Application No. 09/409,659  
Amendment dated October 13, 2003  
Reply to Office Action of July 7, 2003

### REMARKS

FIG. 1

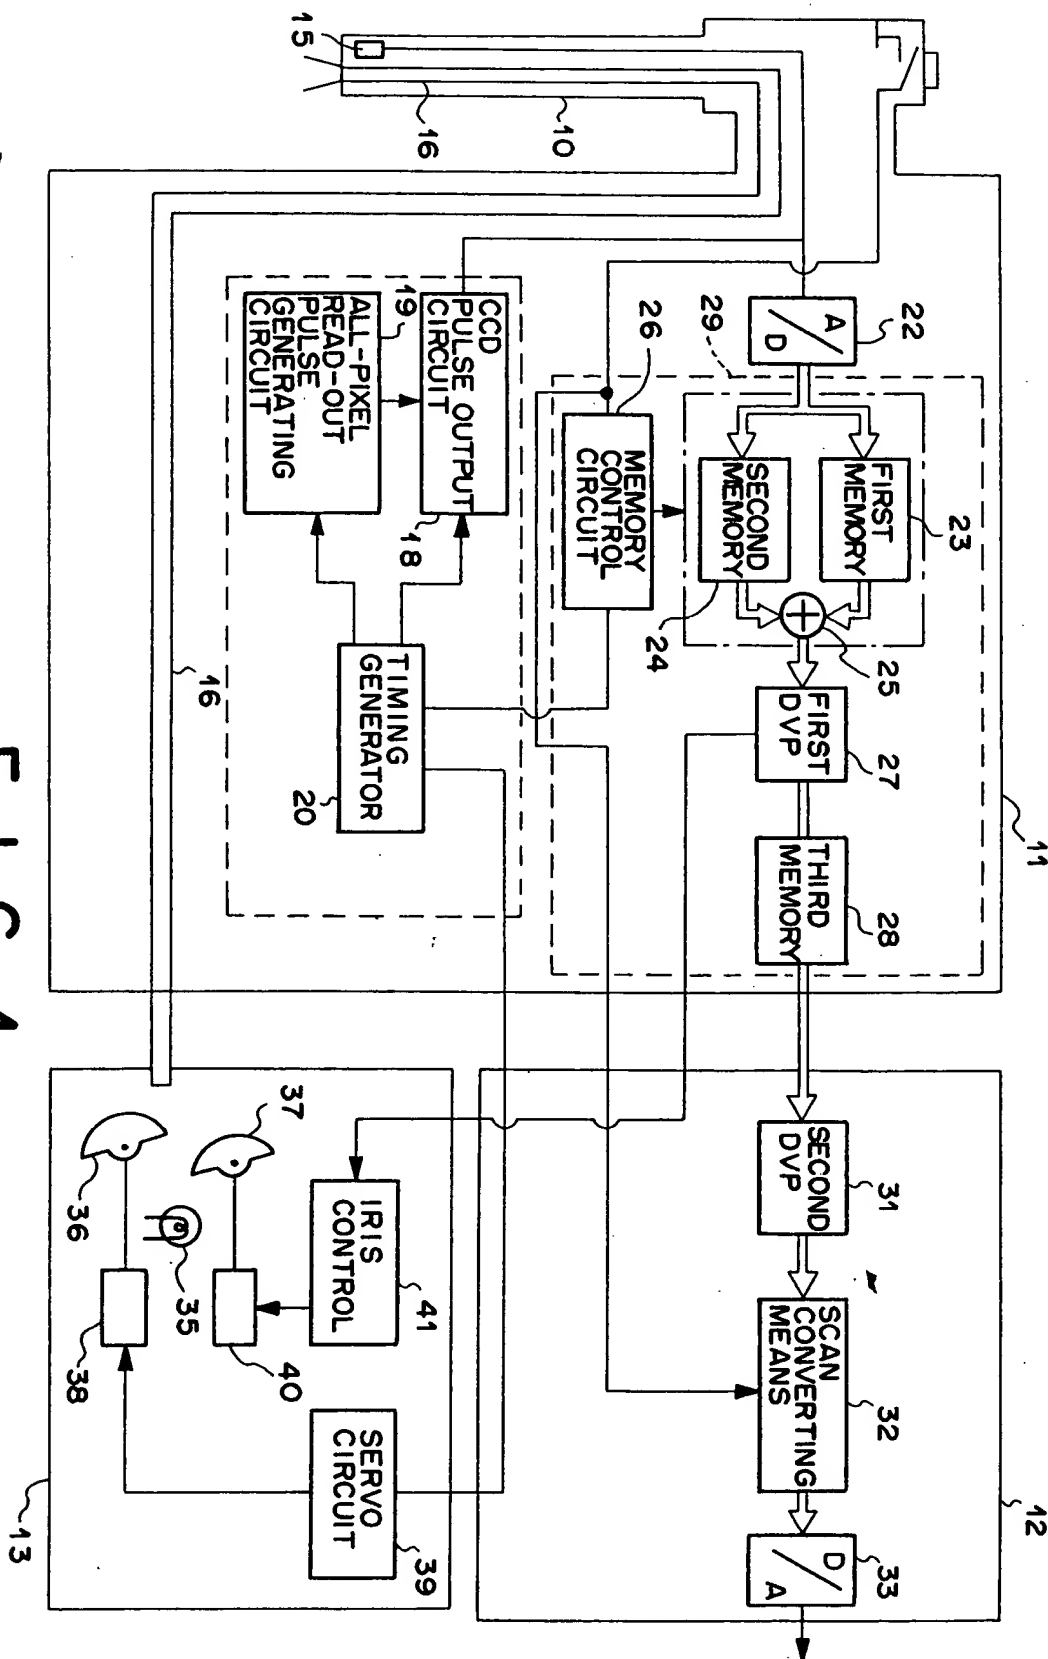
Next, the Examiner rejected to the disclosure because on pages 14 and 15, the second digital video processor is labeled "28" while in FIG. 1 it is labeled "31"; on page 16, line 10 the disclosure states "memory 27" which should be "DVP 27" and on page 23, line 16 the disclosure states "DVP 66" which should be "DVP 67". Applicants have amended the specification appropriately. Accordingly, Applicants respectfully request that this objection to the disclosure be withdrawn.

Next, the Examiner objected to the drawings because FIGS. 1 and 5 include reference sign 21 that is not mentioned in the description and that FIG. 4 includes reference signs A1/A2 that is not mentioned in the description. Applicants have provided replacement drawing sheets that no longer include reference signs 21 and A1/A2. Accordingly, Applicants respectfully
